# **Mobile Intel<sup>®</sup> Celeron<sup>®</sup> Processor at 466 MHz, 433 MHz, 400 MHz, 366 MHz, 333 MHz, 300 MHz, and 266 MHz Specification Update**

Release Date: January 2002

Order Number: 244444-029

**Figure 1. An Example of Microcontroller Driven Thermal Management**

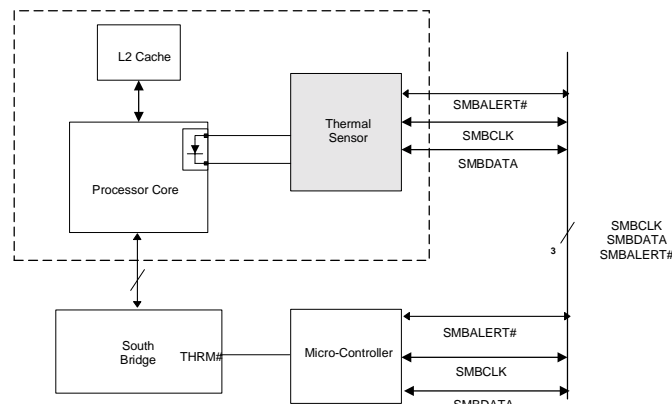
## H29. Thermal Sensor May Assert SMBALERT# Incorrectly

**Problem:** The Intel Celeron Processor Mobile Module has a thermal sensor that monitors the processor core's temperature. Please note that desktop systems could have a similar thermal device. The thermal sensor asserts SMBALERT# if the processor temperature exceeds the temperature limits set in the Alarm Threshold Registers ( $T_{HIGH}$ ,  $T_{LOW}$ ). It also sets the corresponding Status Register bits to identify the cause of the interrupt. Figure 1 gives one example of the how the SMBALERT# signal could be used in a system.

**Figure 2. Workaround Flowchart: SMBALERT#-Driven System**

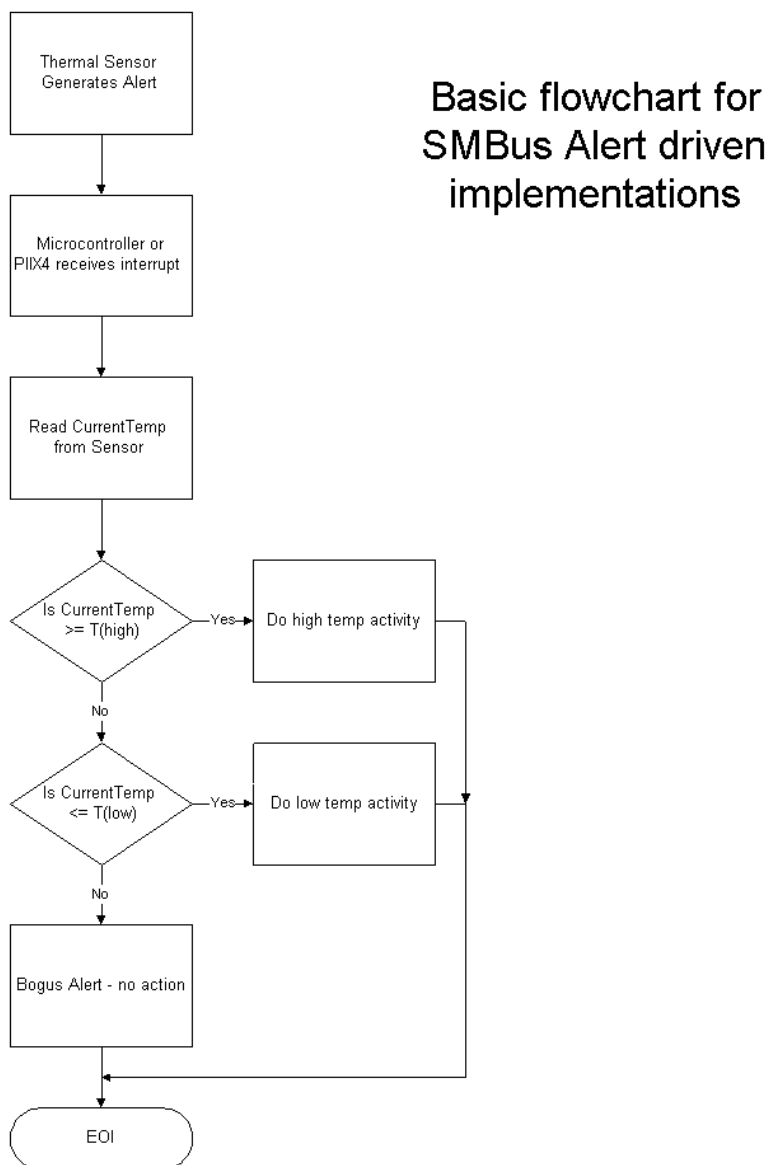
**Implication:** There is no system impact from this erratum if temperature polling is used for processor thermal management. If the SMBALERT# interrupt is employed to manage processor thermal sensing, then servicing the false interrupt may result in premature system action depending on the software and hardware implementations used. The rate of the false interrupts is less than the auto-convert rate of the thermal sensor.

**Workaround:** Three different (mutually exclusive) workarounds are possible:

1. Before servicing an interrupt from the thermal sensor, read and compare the processor thermal reading with the threshold limits ( $T_{HIGH}$  or  $T_{LOW}$ ). Figures 2 and 3 provide basic flowcharts for the implementation of this workaround in an interrupt driven system.
2. If the firmware implemented polls the Status Register only, then before taking any action, re-read the temperature register and do a comparison with the alarm threshold limits ( $T_{HIGH}$  or  $T_{LOW}$ ) to determine if the value is actually still within the temperature window.
3. Use a temperature polling scheme to monitor the processor temperature.
